World Forum for Harmonization of Vehicle Regulations

Working Party on Passive Safety

Seventy-fourth session

Report of the Working Party on Passive Safety on its Seventy-fourth Session

Figure 1-2
Timeline for Dynamic, Static Time Constraint and Static Testing Representing Real Life Conditions

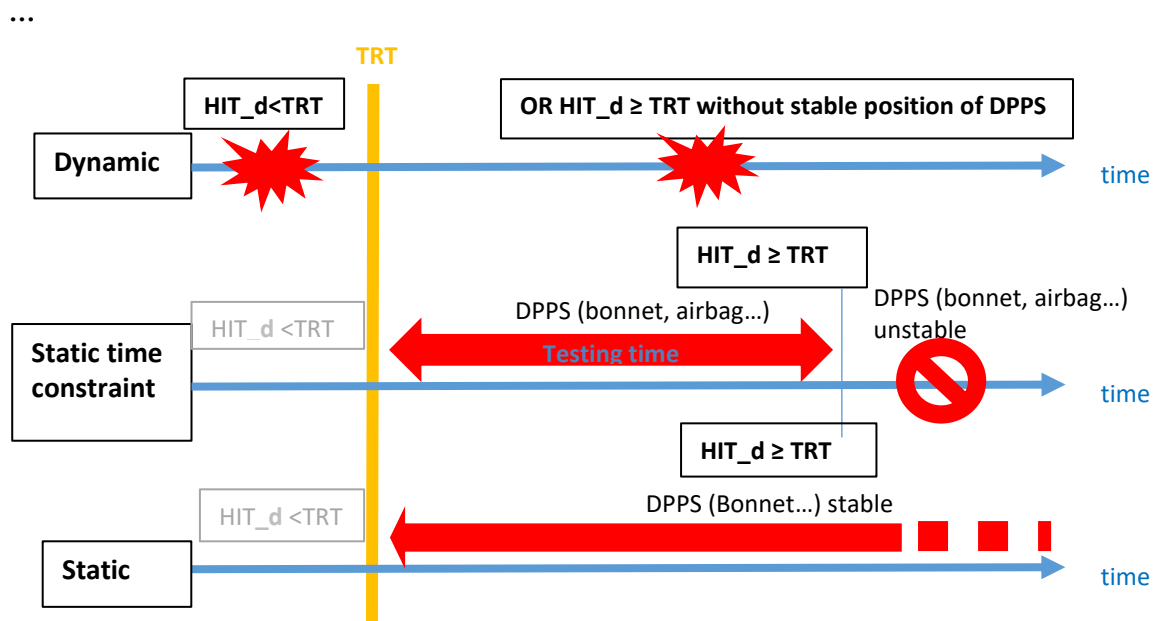
- 1.7.2. A test with **FlexPLI** shall be performed at nominal **velocity (11.1m/s)** at vehicle centreline (Y0).
- 1.7.3. Where ... **but below the lower ...**
- 2.1. TRT... by **using FlexPLI at ... and at the vehicle centreline (Y0).**
- 2.2. ST ... Regulation and **at the vehicle centreline (Y0).**
- 3. Tolerances
 - For verification tests of paragraphs 1.7 and 2 of Annex 1 with **FlexPLI, ...:**
- 4.1. Static test option:
 - If the ... If so, **the headform ...**
 - If ..., **the headform tests ...**
- 4.1.1. Where...selected **pedestrian stature**, as defined in Annex 2, ...
- 4.1.2.1. **Static time constraint condition, linked to the resisting force:**
 - When ... headform **impactor shall ensure ...**

Figure 1

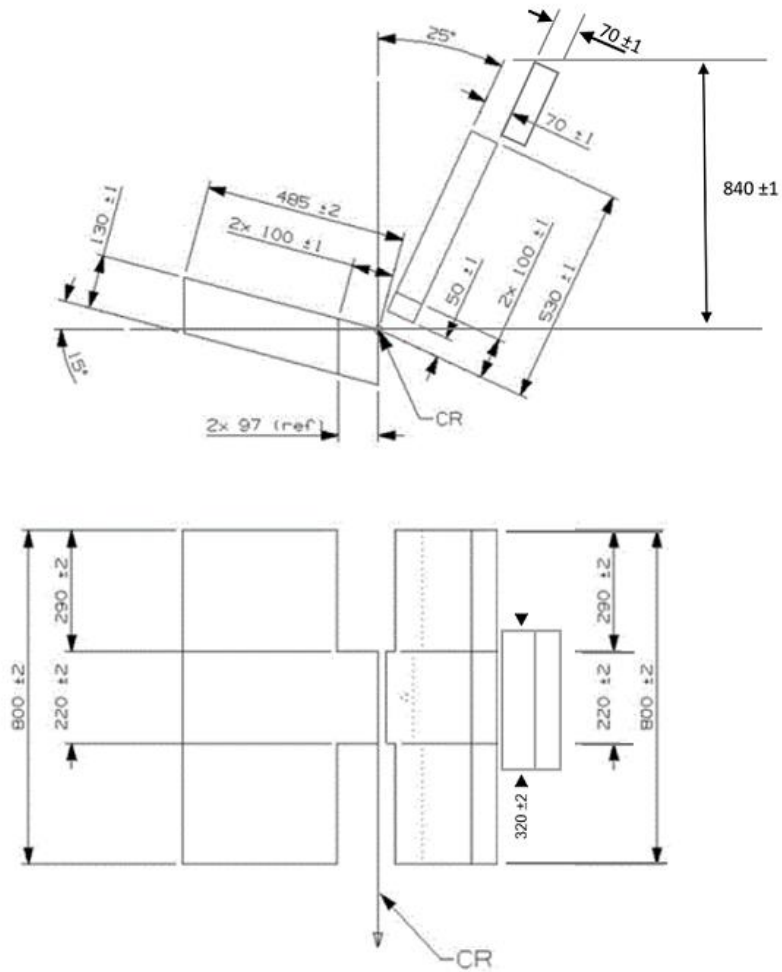
Insert new Annex 6 – Appendix 5, to read:

Annex 6 - Appendix 5

Optional Dummy Protective Device

"3.4. Optional dummy protective device

An optional dummy protective device may be installed on the test bench for the dynamic frontal test of booster cushion when tested on the test bench described in this Annex.

The dummy protective device may be covered with the Polychloropren foam of the lateral impact door as defined in Appendix 3 of this Annex, or an alternative material, at the decision of the technical service.

The dimensions of the dummy protective device are given in Appendix 3 of this Annex.

The forward face of the dummy protective device shall be parallel with the back of the backrest. The design of the dummy protective device shall be such that it does not interfere with the manikin when positioned on the test bench. Furthermore, the dummy protective device shall not interfere with the dummy and/or the adult 3-point belt during the dynamic test until the maximum horizontal head excursion has been reached.
